MONUMENT STEEL STRUCTURES

FINAL DRAINAGE STUDY

APRIL 2019

Add PCD File No. PPR1919

POINT PRECIPITATION FREQUENCY ESTIMATES

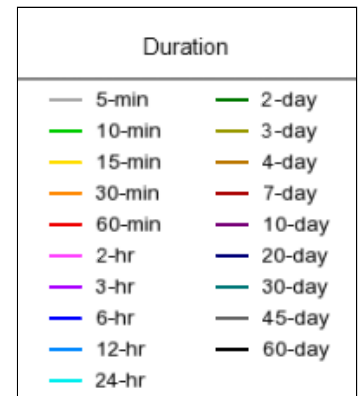
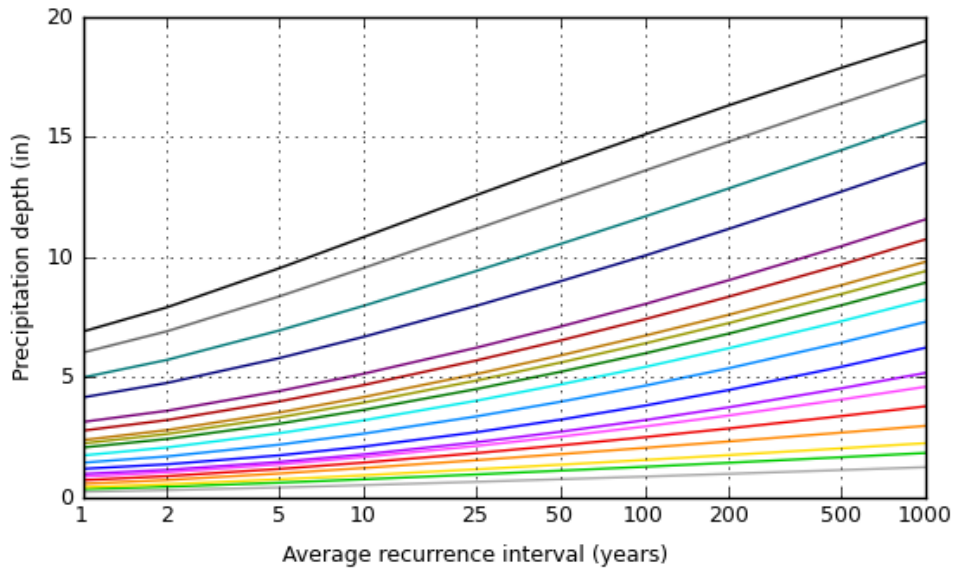
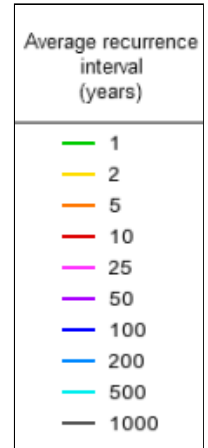
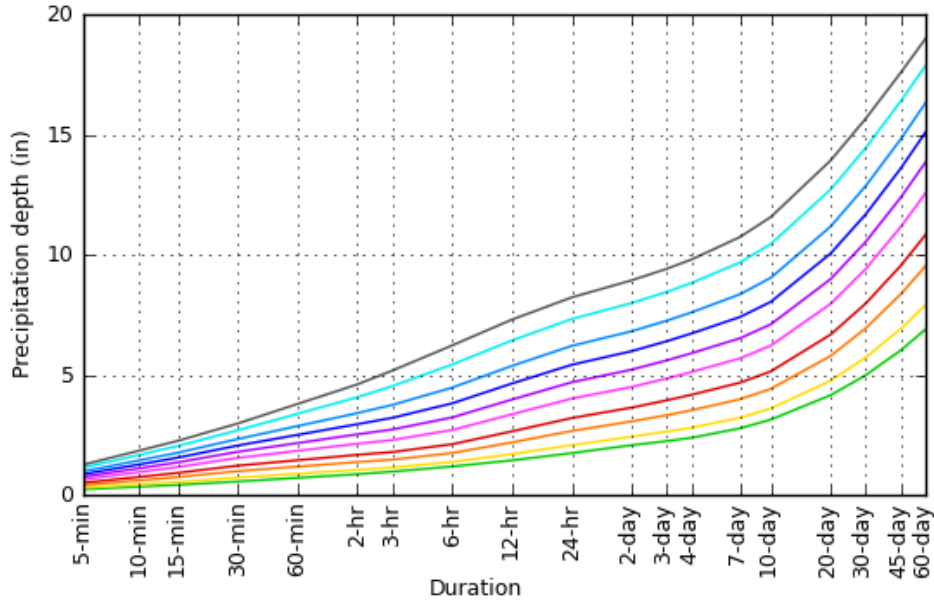
The design point rainfall used is per the City DCM vs the NOAA Point Precipitation provided at the beginning of Appendix A. What is the NOAA information being used for? Remove if not being used.

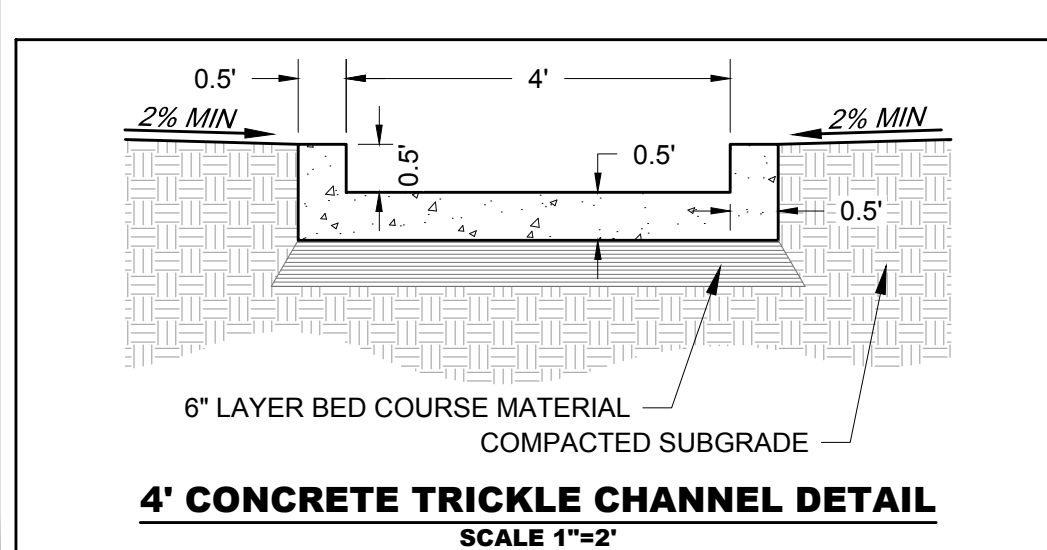
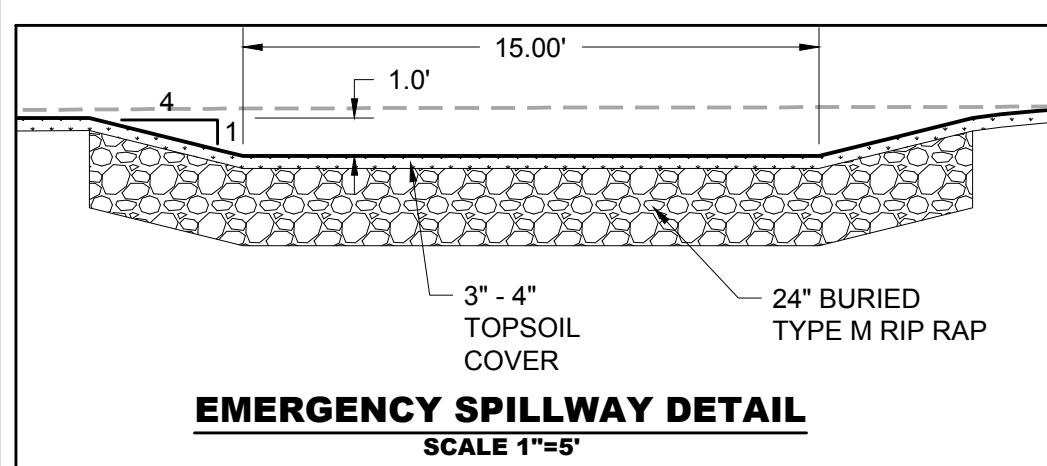
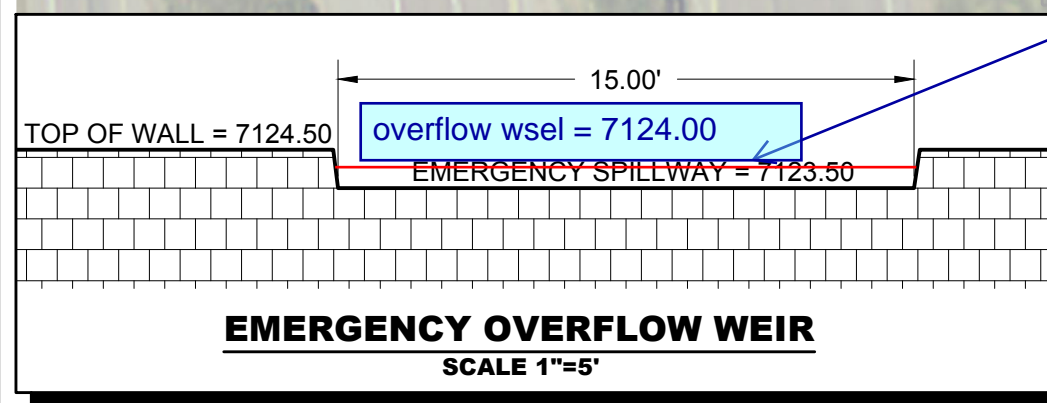
Revise. Insufficient freeboard as designed. Provide 1 foot of freeboard above the spillway design-flow depth.

For DP5, provide the Q release.

Provide a pond summary table. Pond volume required vs provided (WQCV, EURV, 100yr)

CONSTRUCTION DOCUMENTS
MONUMENT STEEL STRUCTURES
OUTLET STRUCTURE
 18910 BASE CAMP ROAD
 MONUMENT, COLORADO

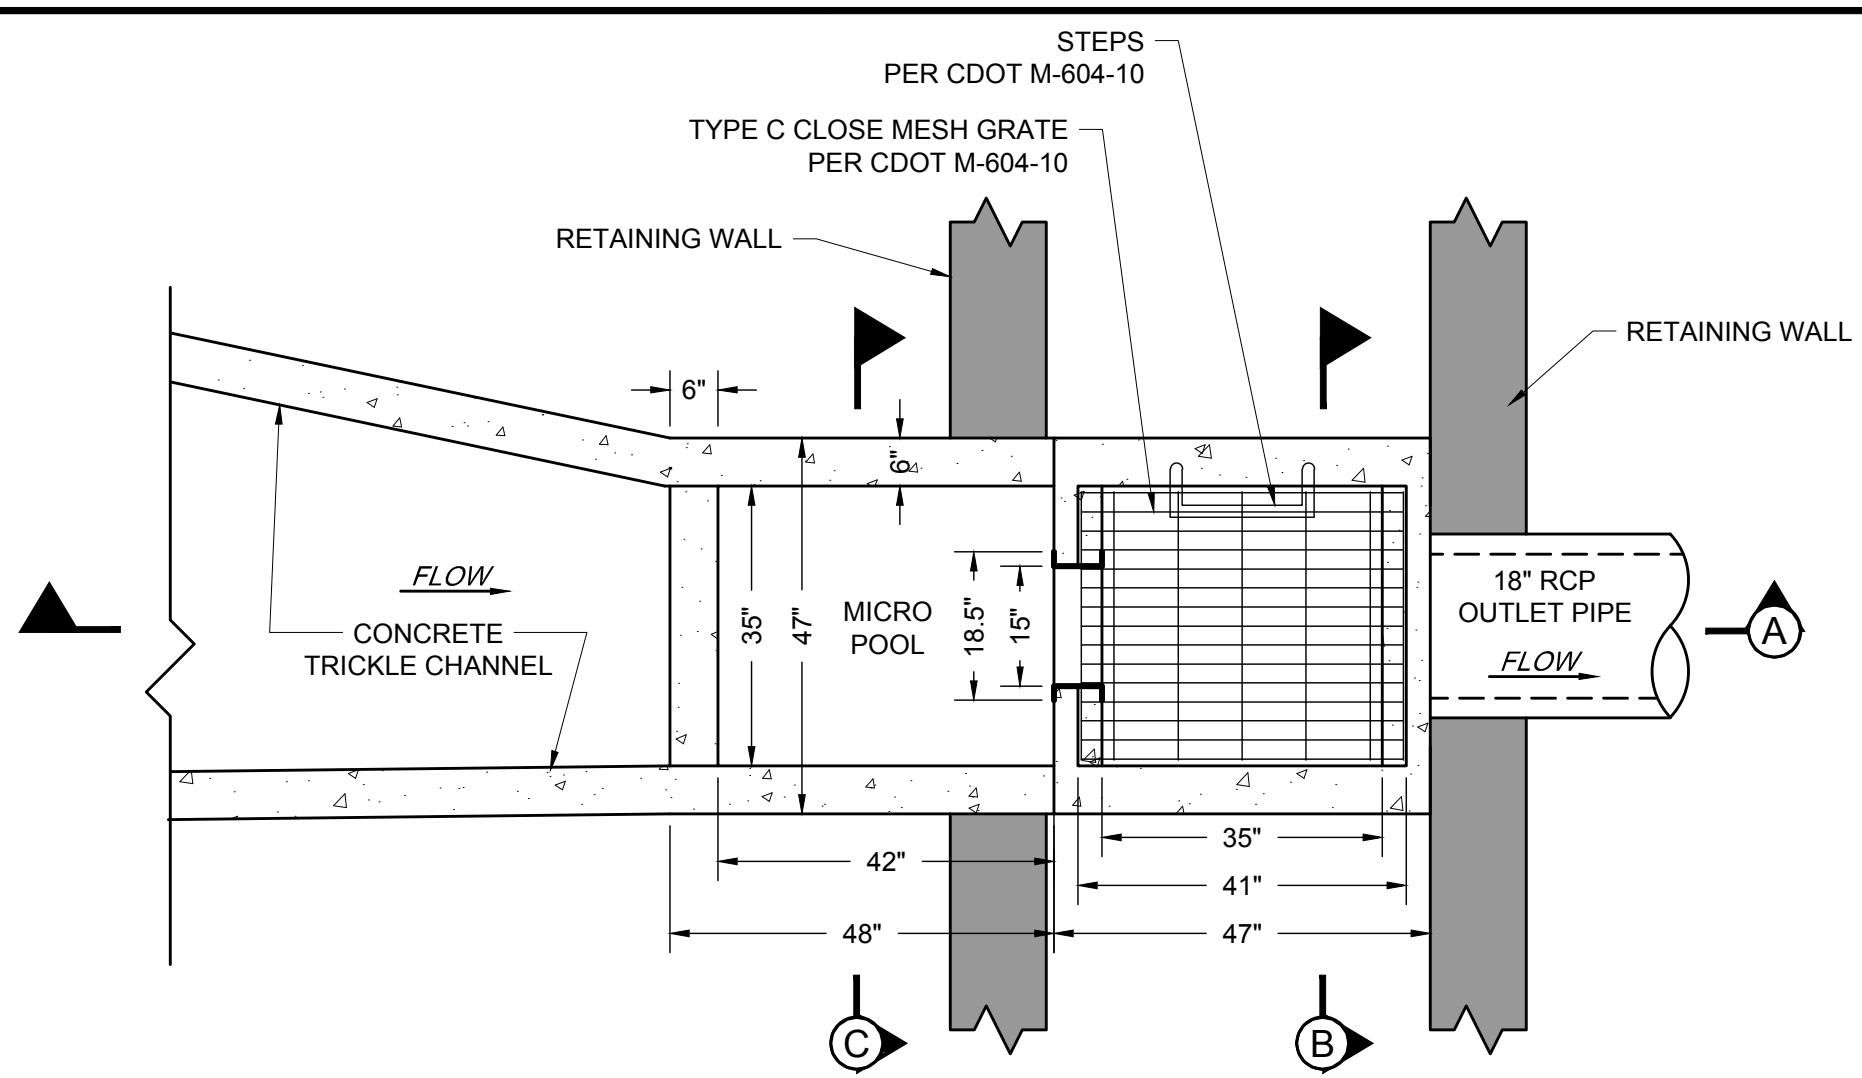
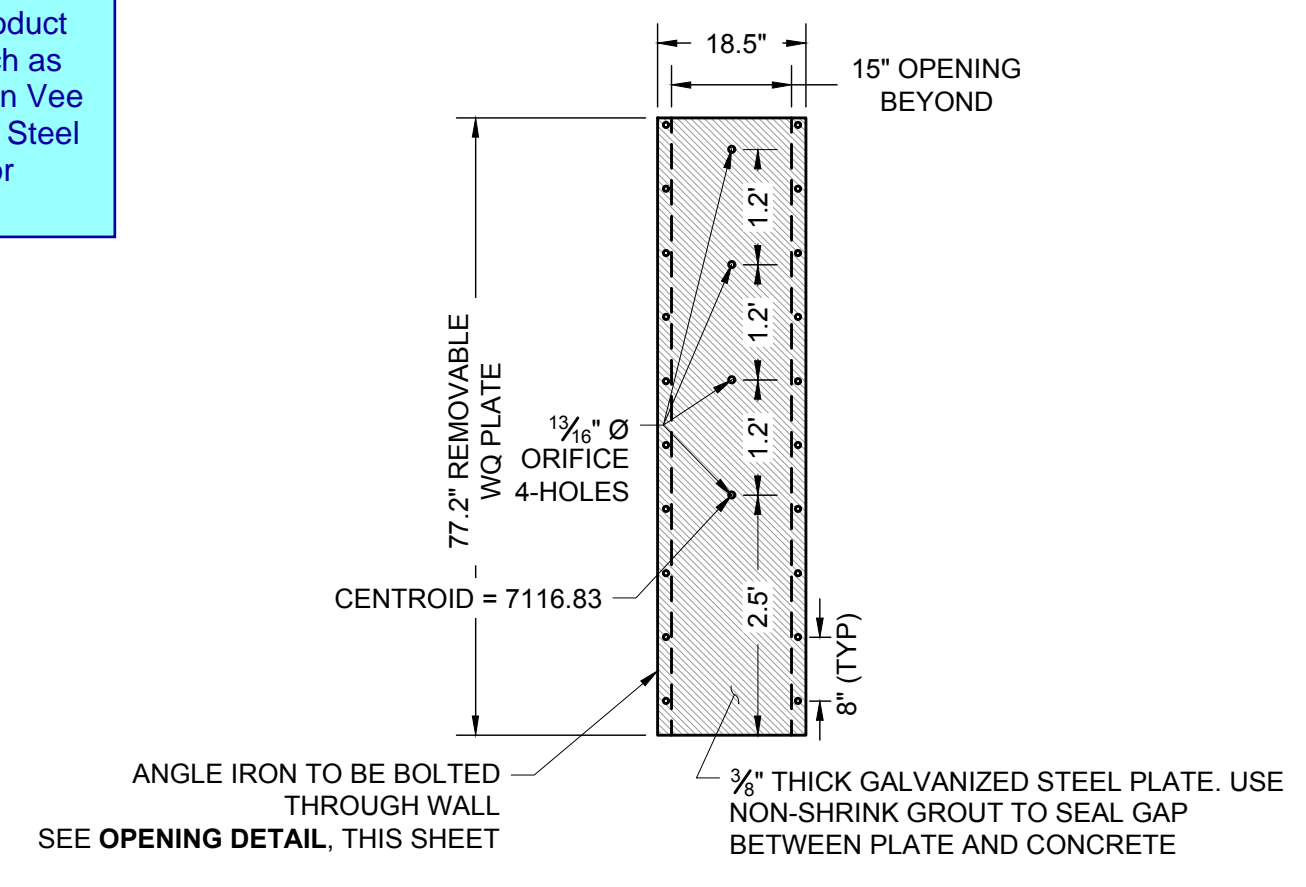
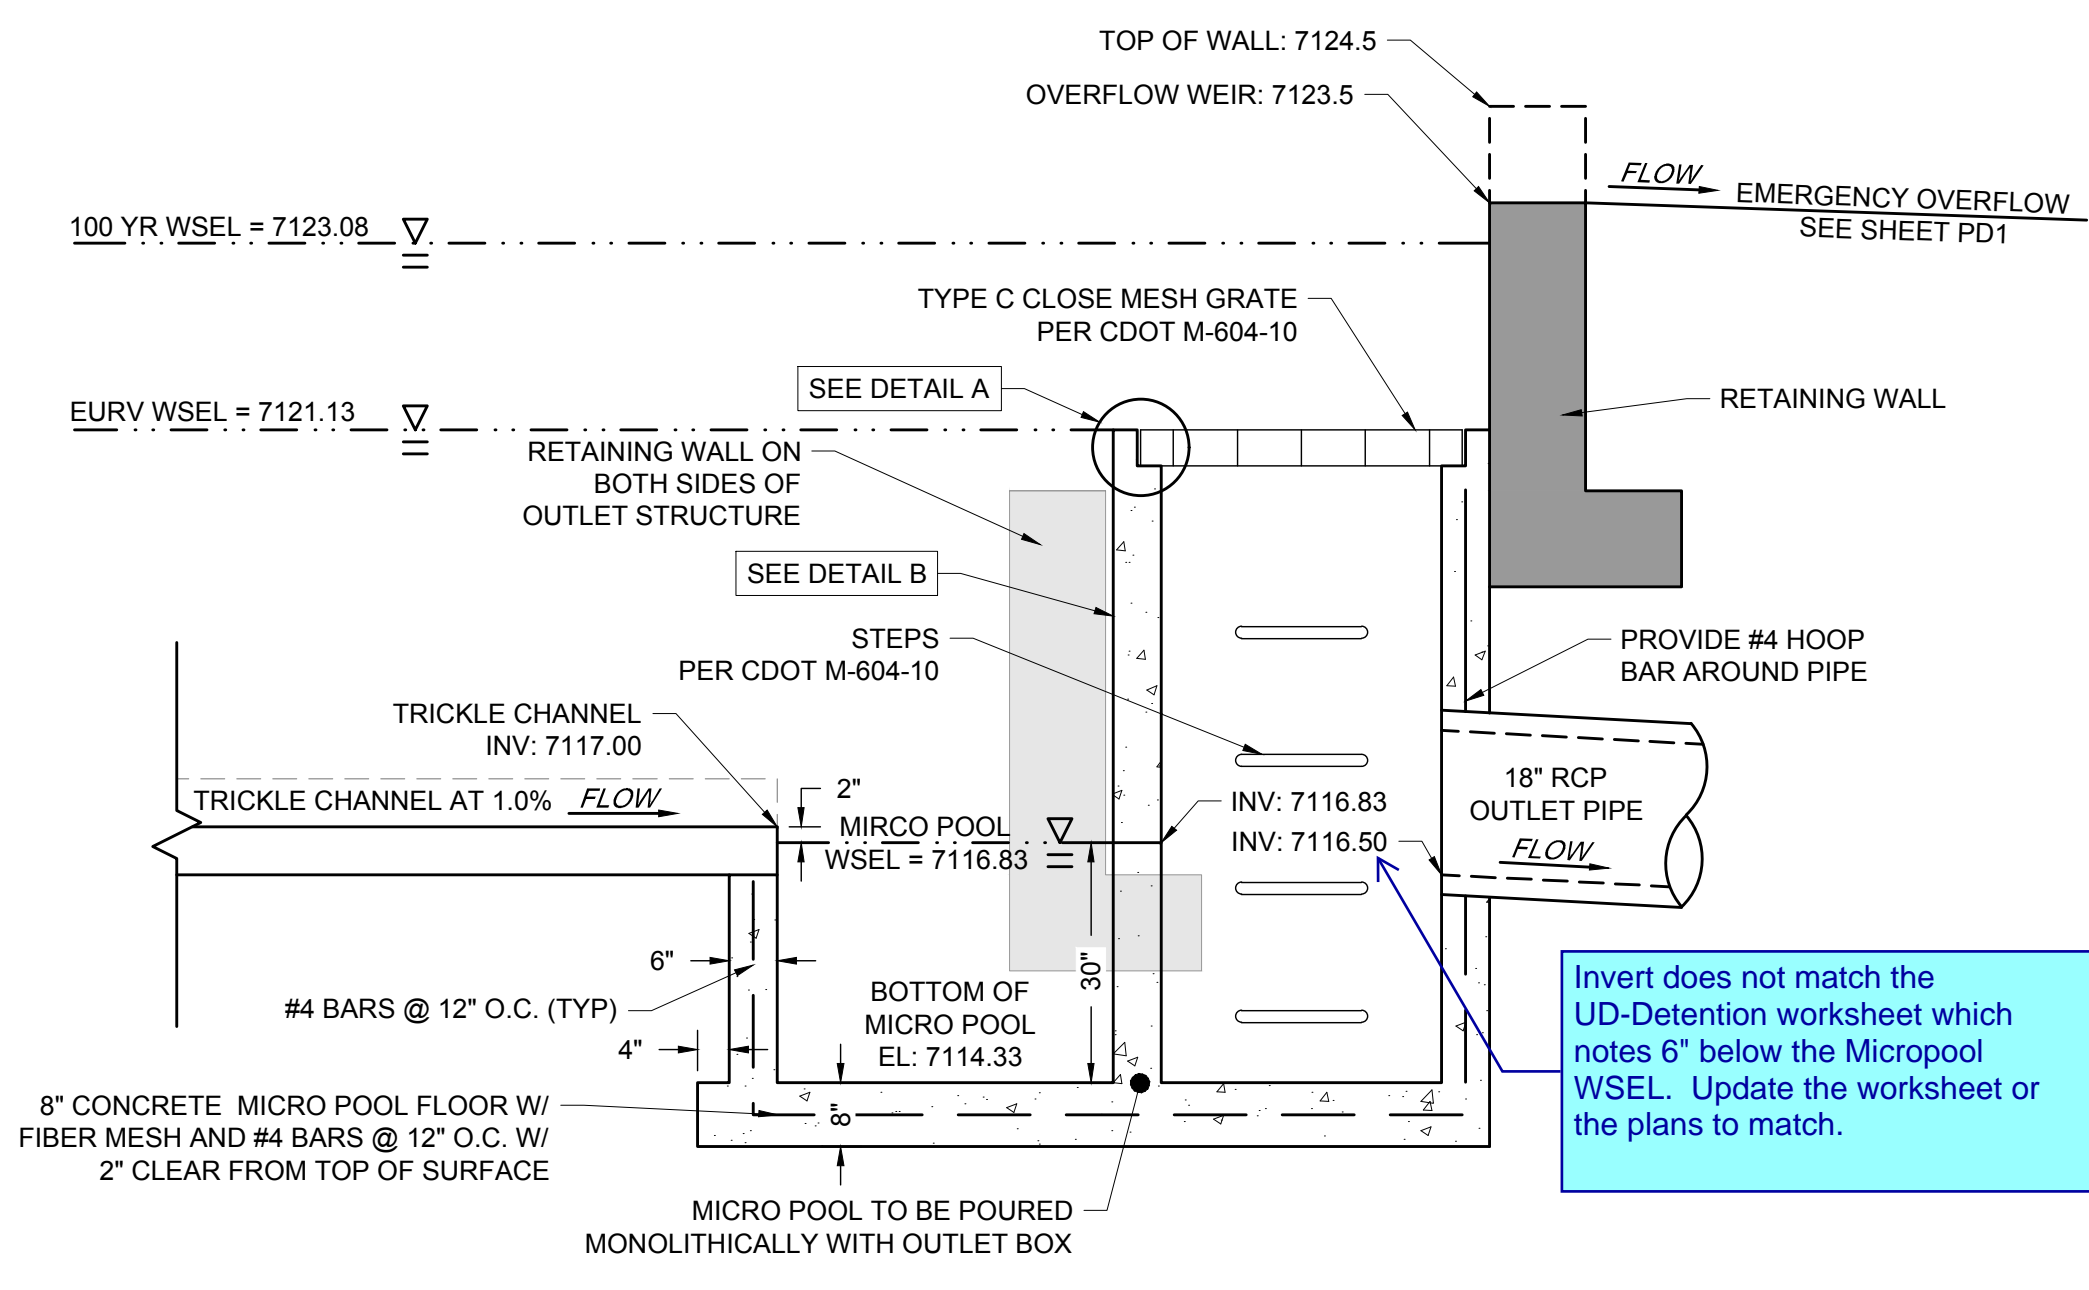
Remove the Outlet Structure details from the drainage report. Include the outlet structure details with the Grading and Erosion Control Plans set.

DETENTION POND OUTLET STRUCTURE MODIFIED TYPE C
 SCALE: 1"=2'

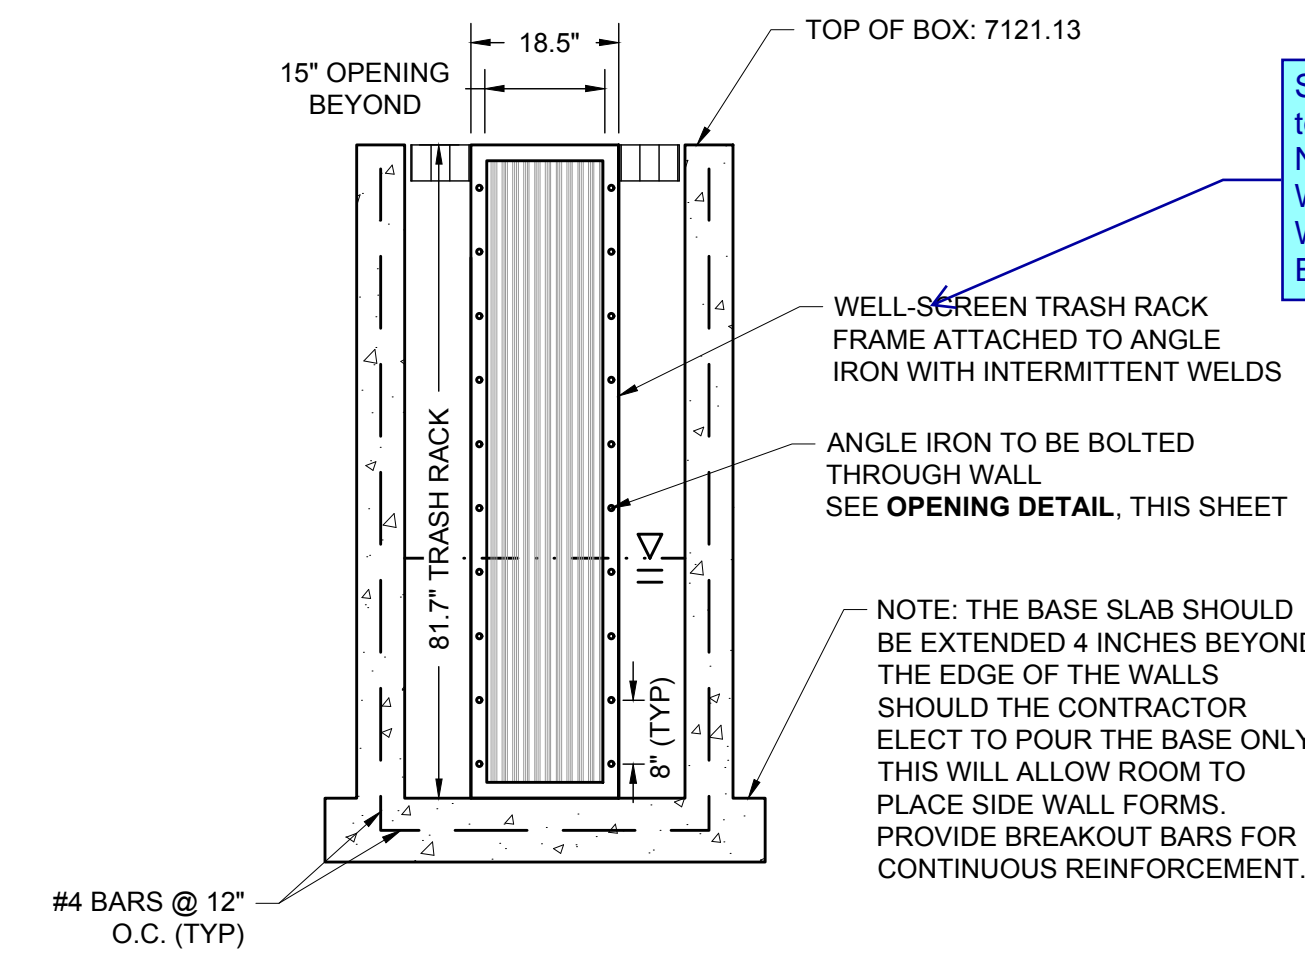
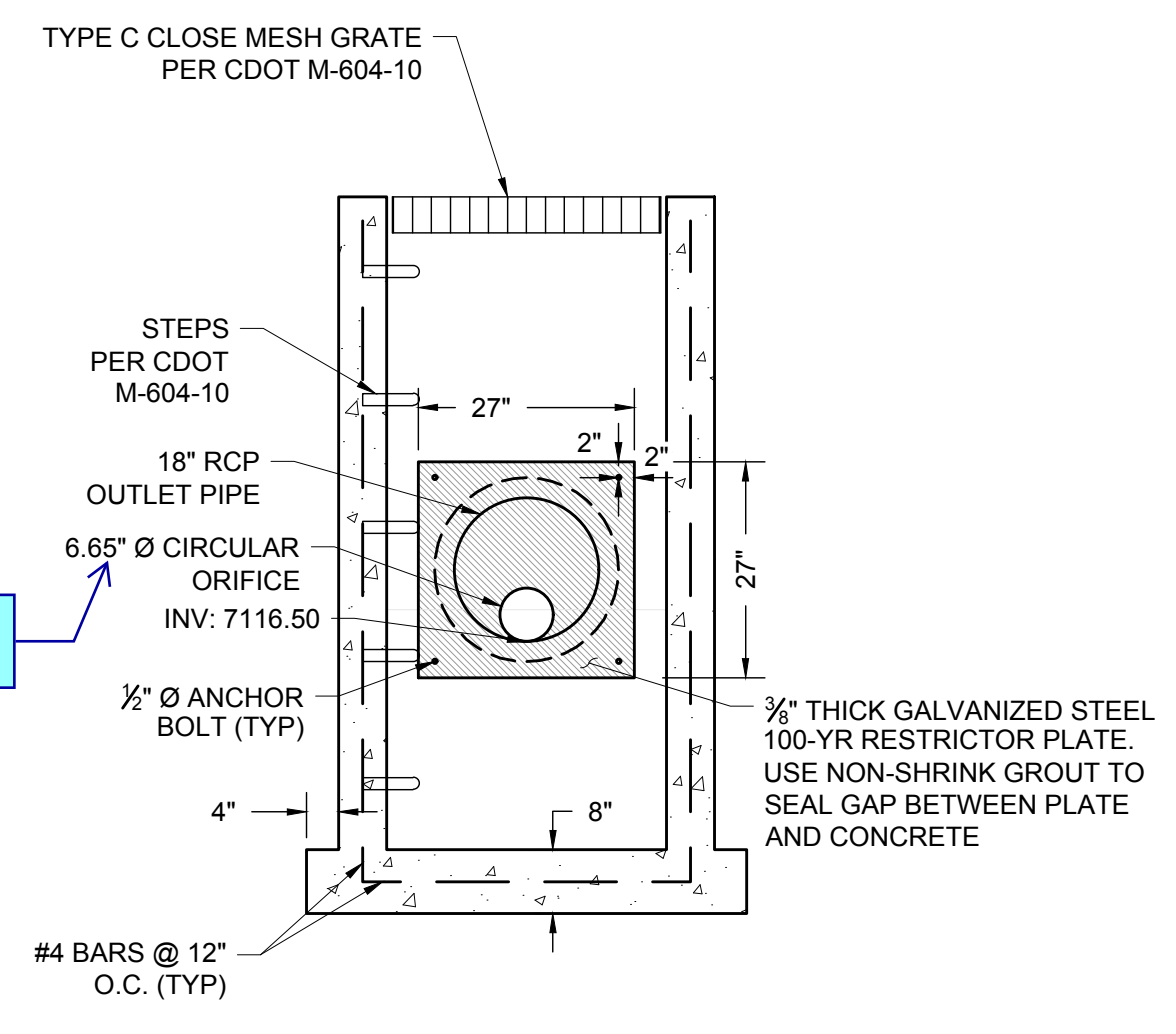
Invert does not match the UD-Detention worksheet which notes 6" below the Micropool WSEL. Update the worksheet or the plans to match.

revise the .65 to standard fraction.
